Change Bulletin			 Tesco Corporation 5616 – 80th Avenue SE Calgary, Alberta, Canada T2C 4N5 Tel: 1-877-TESCO-77 (North America) Tel: 1 (713) 359-7195 (AMSS 24-hour support) Tel: 1 (713) 359-7295 (International) Email: bulletins@tescocorp.com www.tescocorp.com www.tescoparts.com
No: CB052	Rev: 1	Date: October 30, 2013	
PLC Upgrade and Siemens VFD Update			
<input checked="" type="checkbox"/> Internal Use Only <input type="checkbox"/> External Use			
			<input type="checkbox"/> Mandatory <input checked="" type="checkbox"/> Recommended

OEM Changes and Impact

A software upgrade is required based on recent changes made by the Original Equipment Manufacturer (OEM):

Figure 1: Proficy Software Required

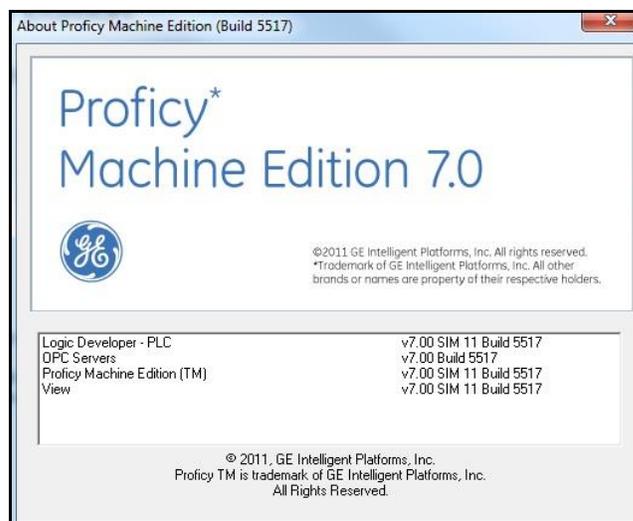
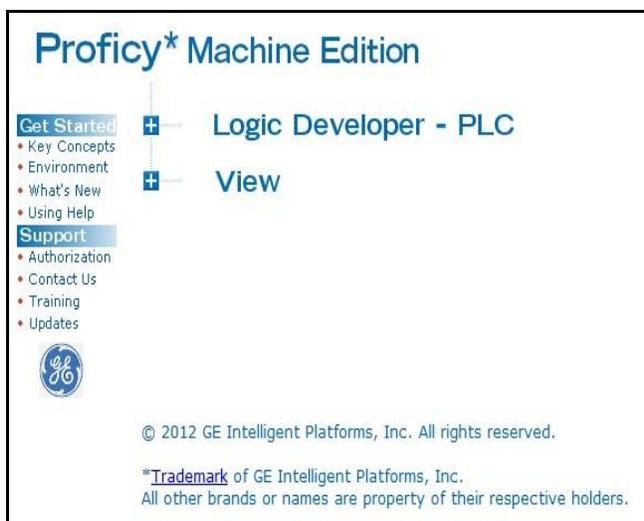
- TESCO uses the GE FANUC 90-30 series PLC in a number of Top Drives for the control system, however, GE is phasing out the 90-30 series. The new GE PACSystem™ RX3i series PLC has been selected to replace the 90-30 series PLC. In order to download PLC code to the GE RX3i PLC, a Proficy Machine Edition (PME) 7.0 Professional SIM 11 is required.
- ESI Models Only: In order to download code to the Human Machine Interface (HMI) unit on the ESI-1350 driller's panel, a Proficy View license is required. It is typically installed with the Proficy software but requires license activation at an extra charge.

- TESCO Technicians' laptops must be upgraded with PME 7.0 SIM 11.
- IT must add Proficy View license on the upgrade timelines being scheduled by the TESCO IT Department.

Figure 5: RX3i CPU Module with Ethernet Port

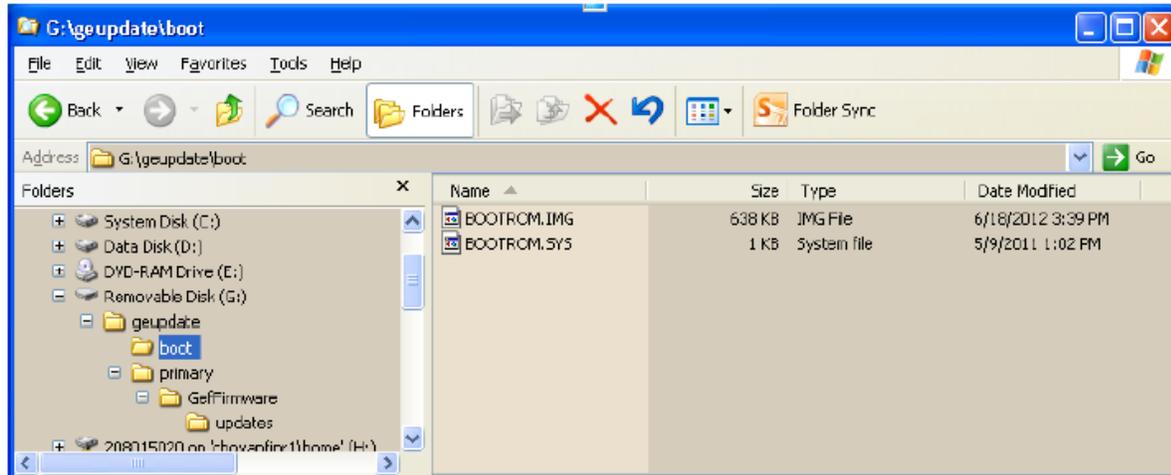
- The GE Fanuc 90-30 series PLC uses a serial port to download code from a host computer to the PLC. The new GE RX3i series uses an Ethernet interface to communicate and download code.

1. Connect one end of the Ethernet cable to host computer and the other end to PLC.
2. Change the IP Address on the host computer (see *How to change TCP/IP settings*).
Note: By default, the RX3i CPU uses the IP address 192.168.0.100.
3. Open the Proficy software and load the appropriate PLC program.
4. From the menu, Click *Target* -> *Go online with "x"* where x is the project name.
